City of Port Orchard
City Hall Building Improvements

ADDENDUM #1

April 19, 2023

LEVEL 1 - DEMO PLAN

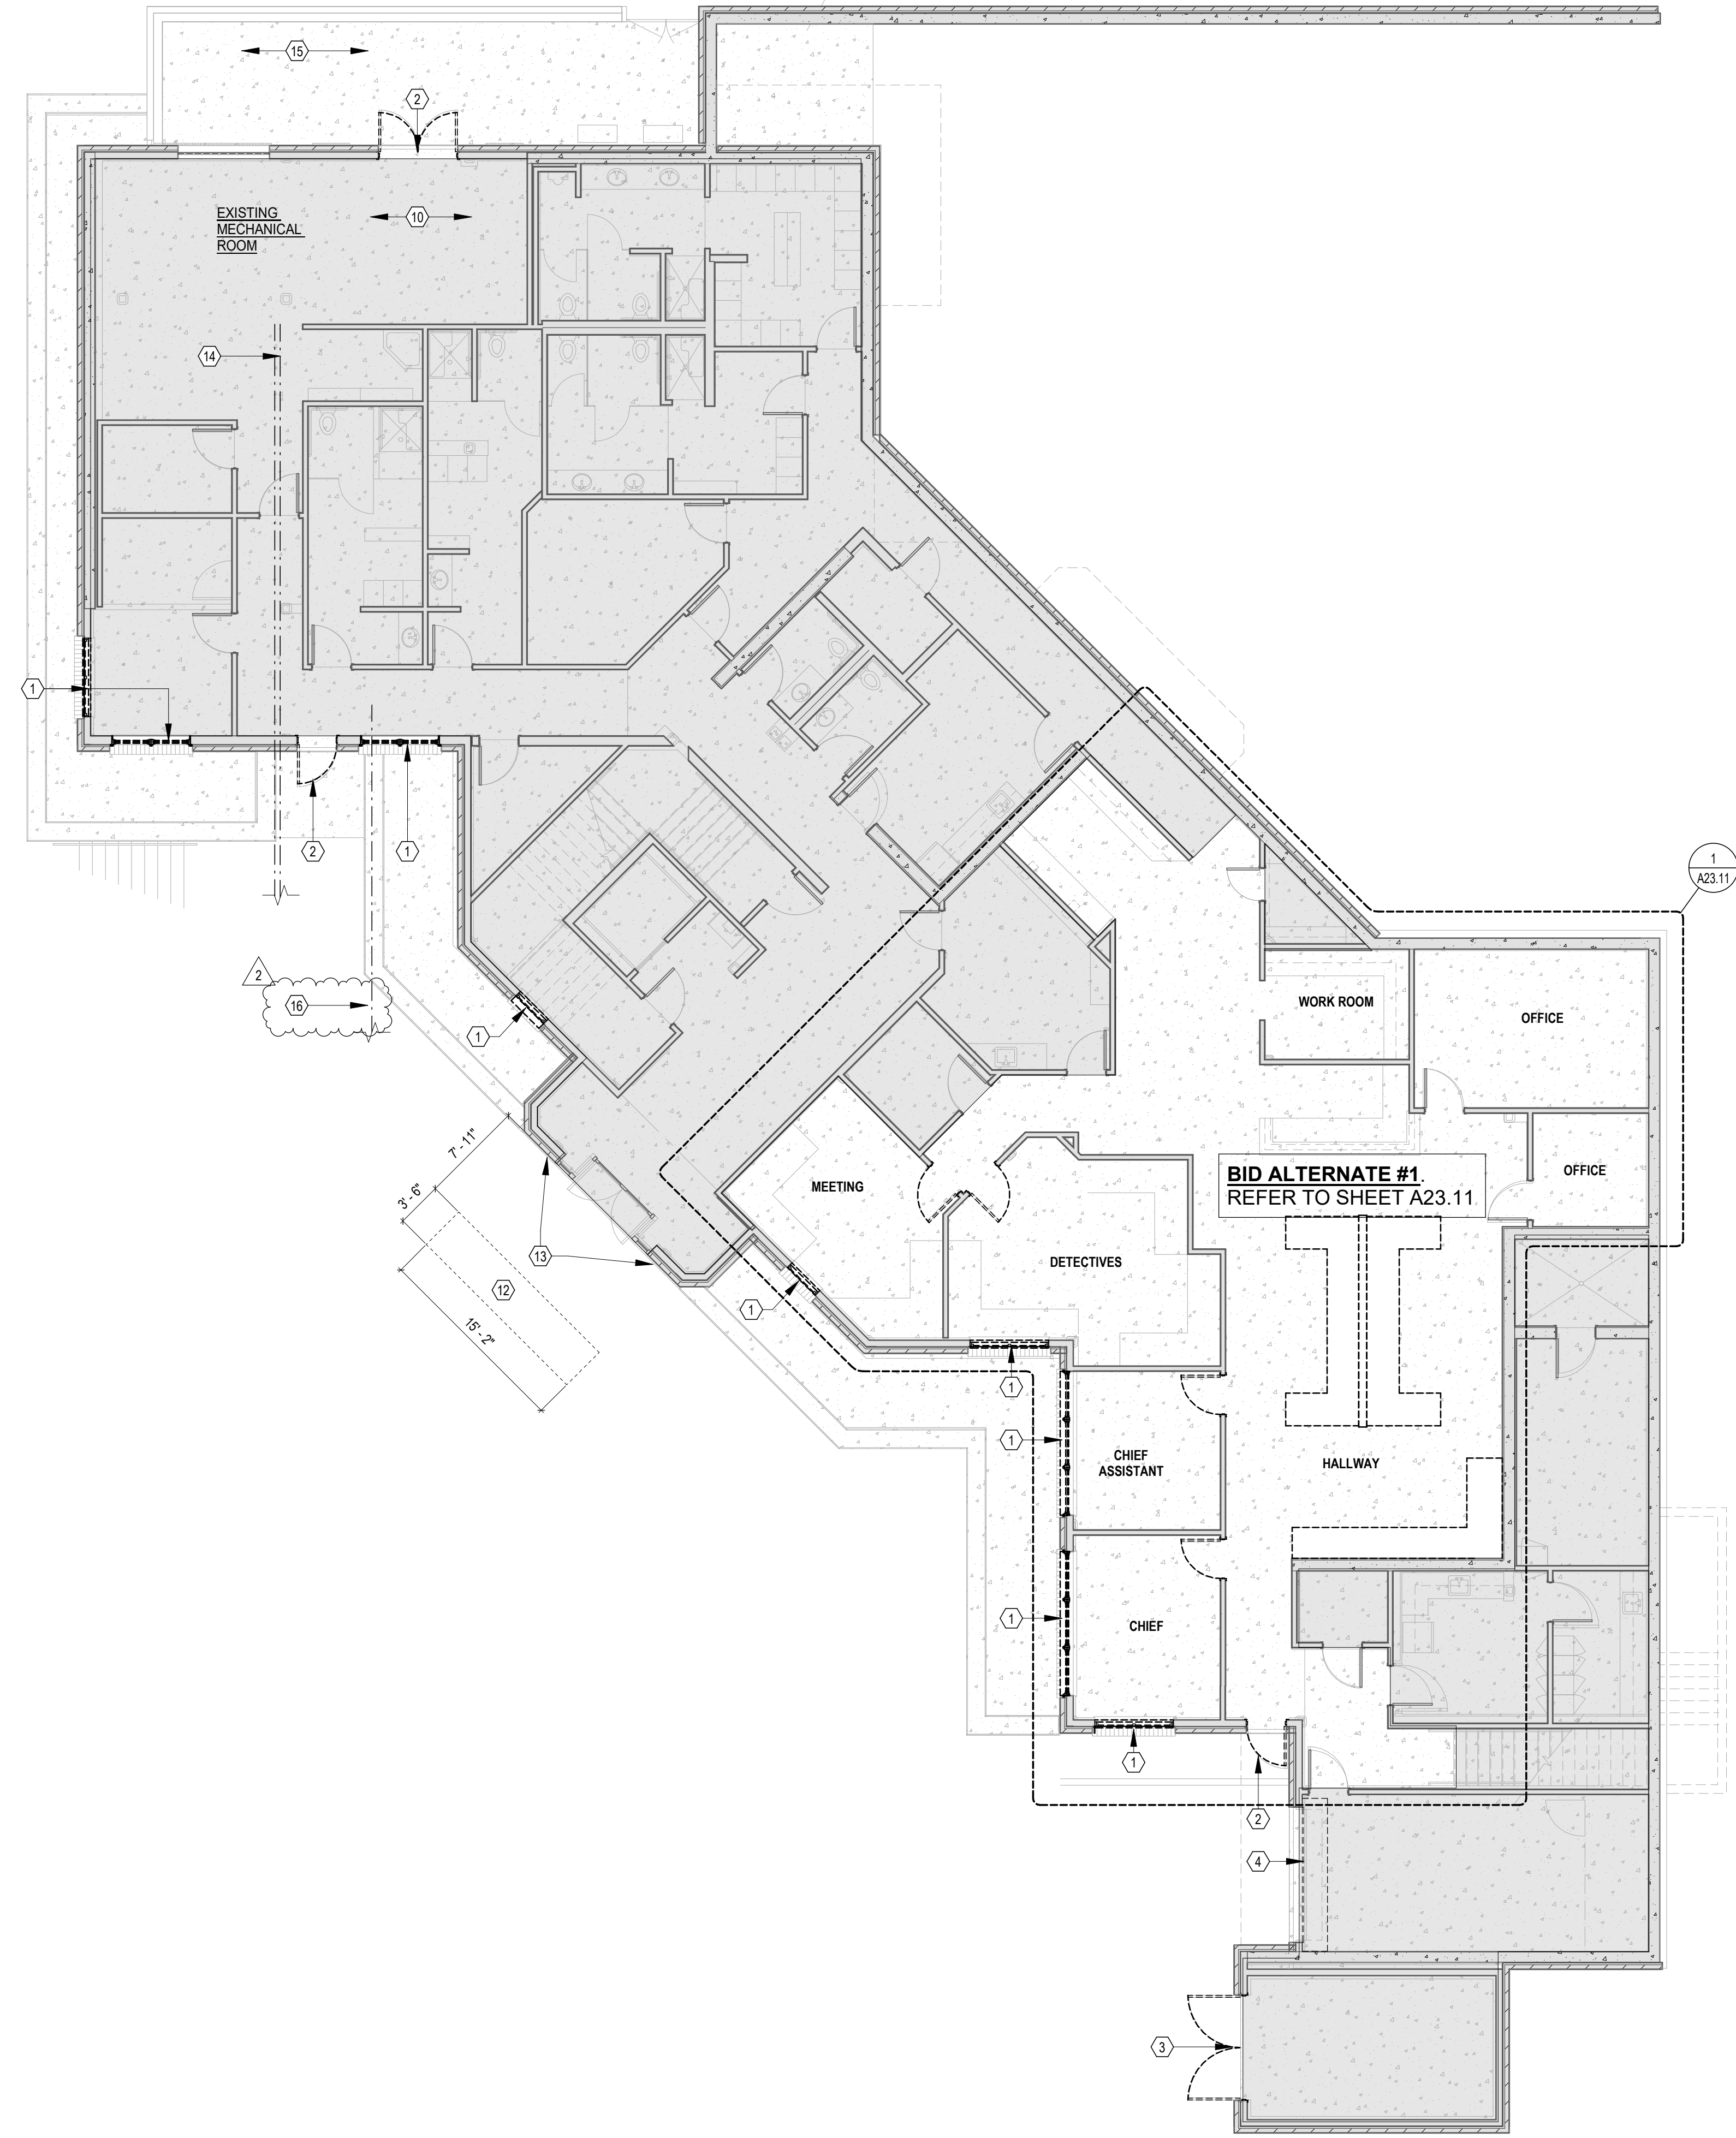
- ITEM 1. Sheet A20.01 - The approximate location of the chiller and generator lines has been added to the plans. The location shown is for reference only. These will still be abandoned in place. No change in scope.
- ITEM 2. Sheet A20.03 - The approximate location of the chiller and generator lines has been added to the plans. The location shown is for reference only. These will still be abandoned in place. No change in scope.
- ITEM 3. Sheet A35.03 – Details 1, 2, and 3 have been updated to show a metal cornice versus the “molded millwork.” Material to be a pre-finished metal per detail 3/A35.02.

LEVEL 1
LIGHTING FLOOR
PLAN

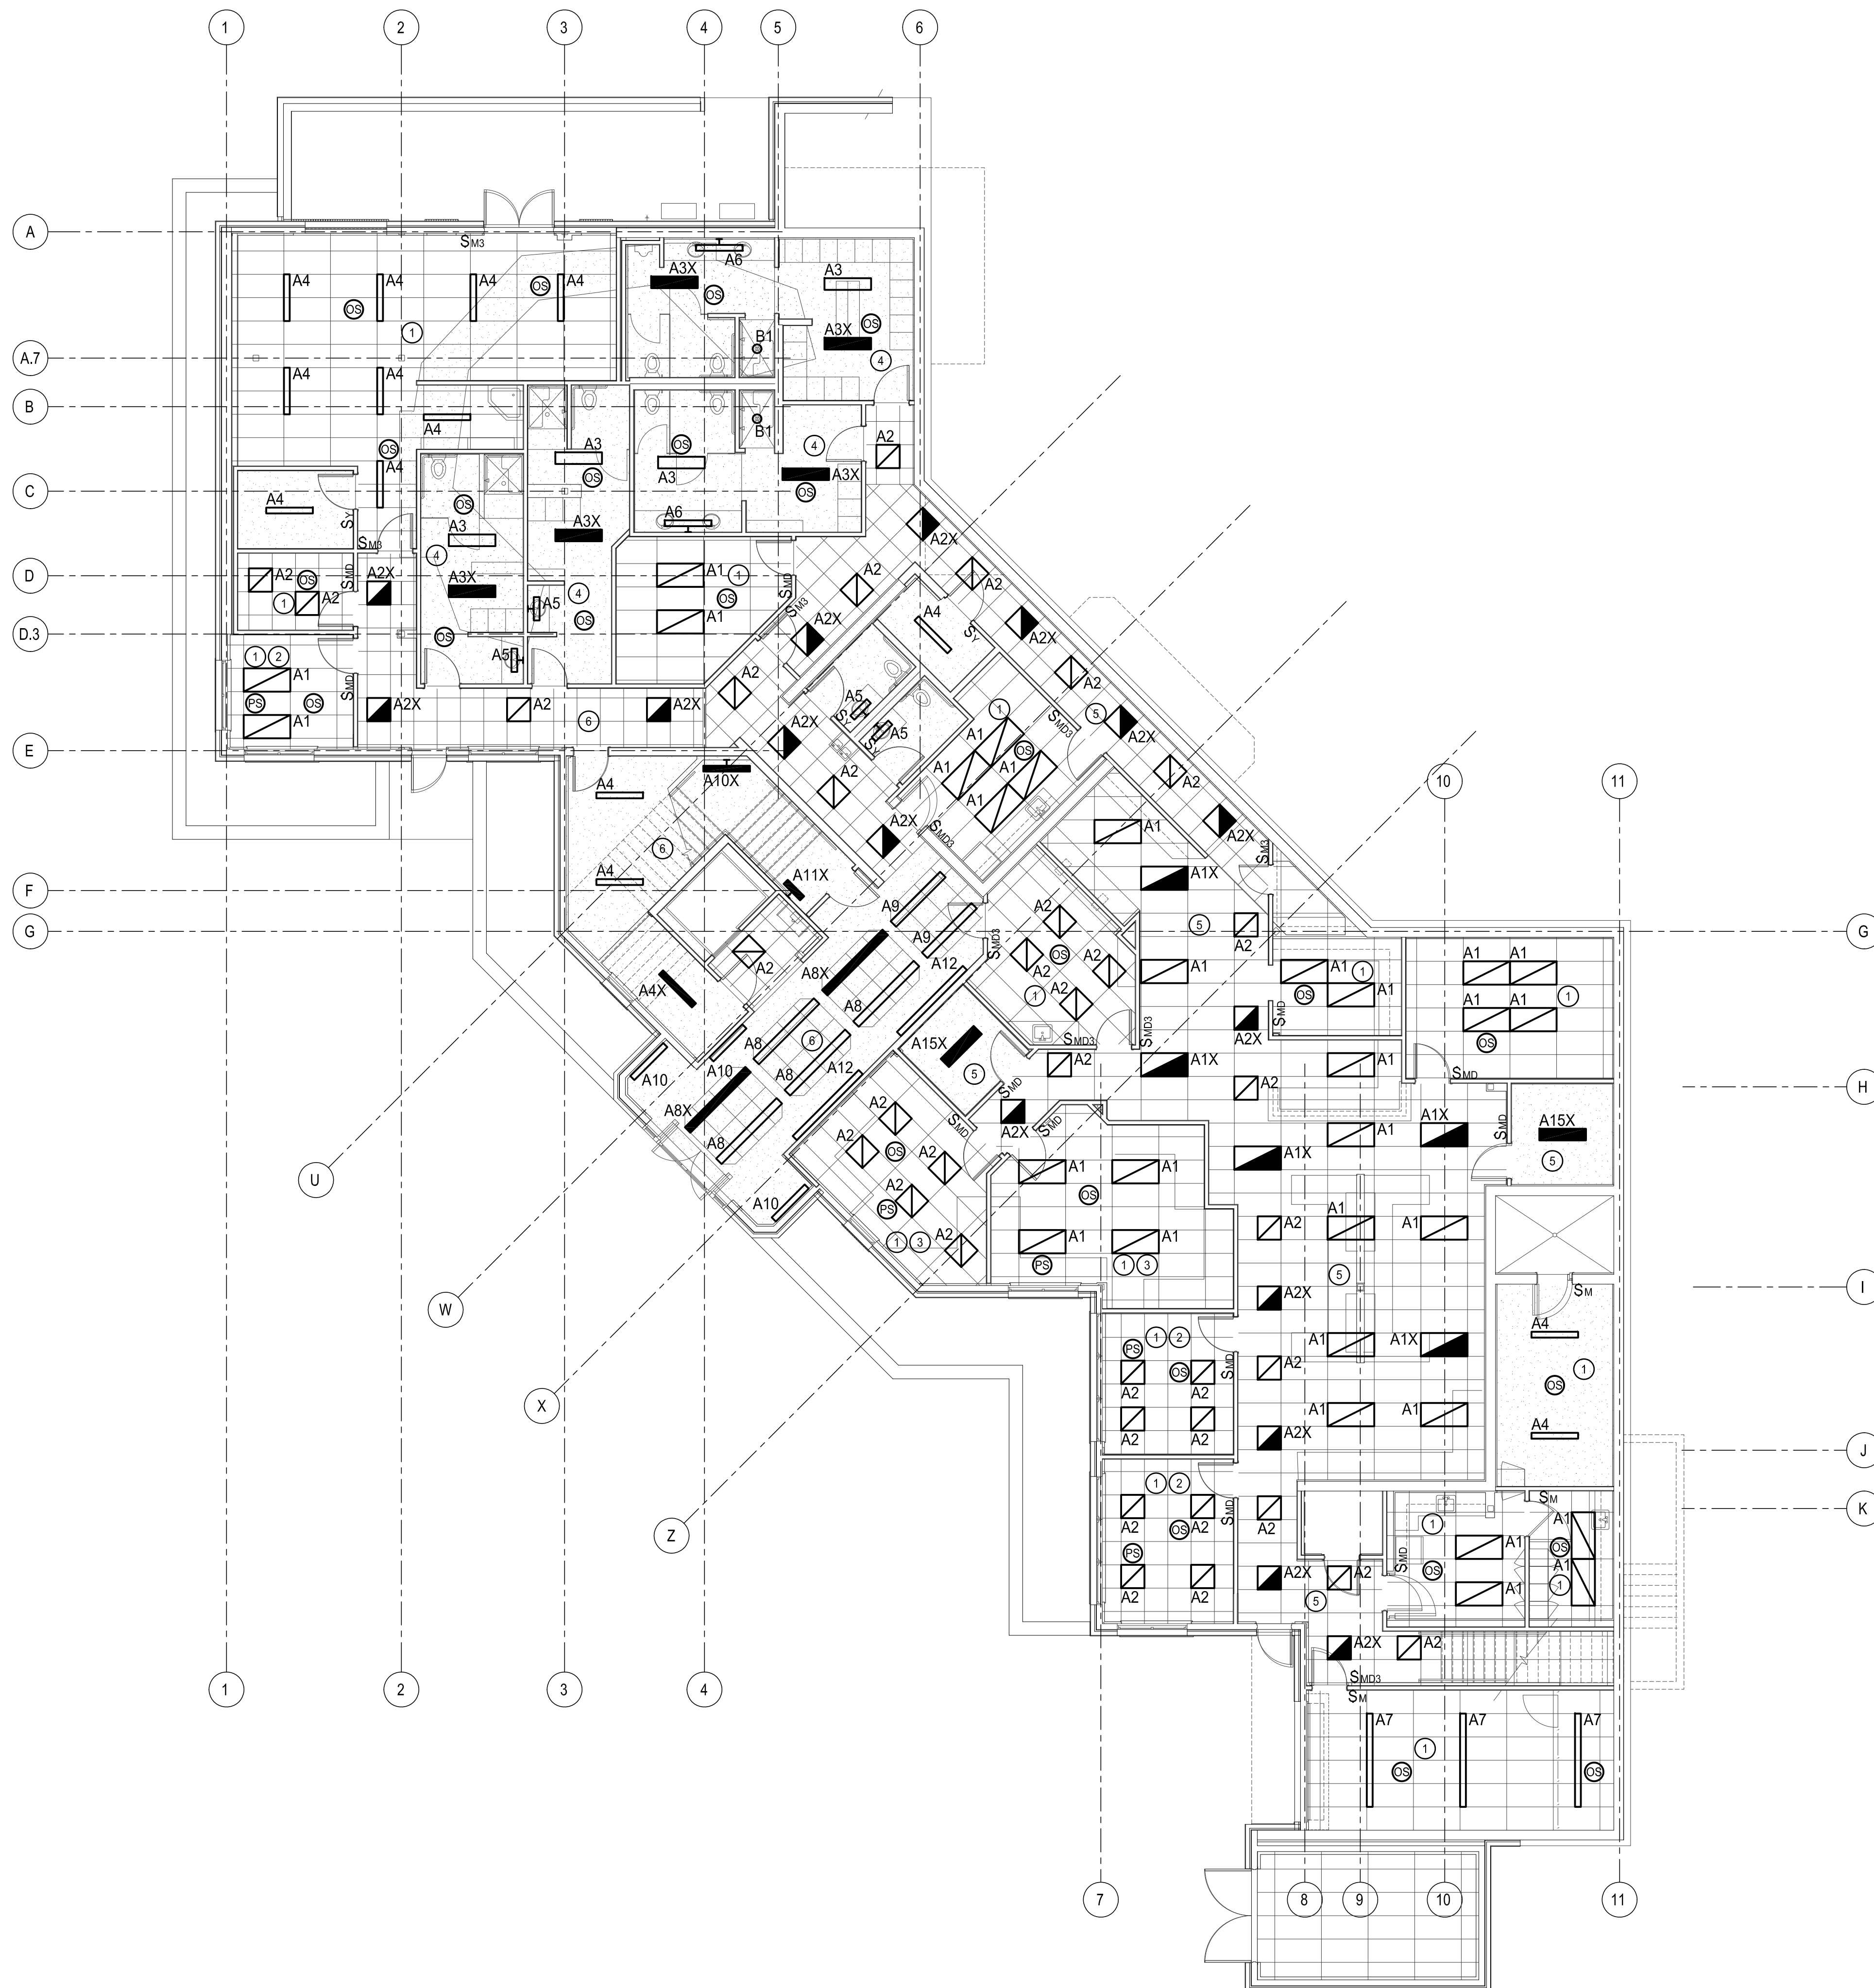
- ITEM 1. Sheet E00.01 – Replace Sheet
- a. Changed C2 fixture to 1x4. This is an approximate dimension. Match existing as close as possible.
 - b. Added X1 fixture for exit signs
- ITEM 2. Sheet E20.01 – Replace Sheet
- a. Added note for replacing exit signs
- ITEM 3. Sheet E20.02 – Replace Sheet
- a. Added note for replacing exit signs
- ITEM 4. Sheet E20.03 – Replace Sheet
- a. Conference Room revision to the lights. Originally showed (4) A2 lights. Changed to (2) C2 lights.
 - b. Added note for replacing exit signs
 - c. Graphical update to show C2 fixture as a linear fixture.
- ITEM 5. General Note added that all Exit Signs are to be replaced and meet the current code.
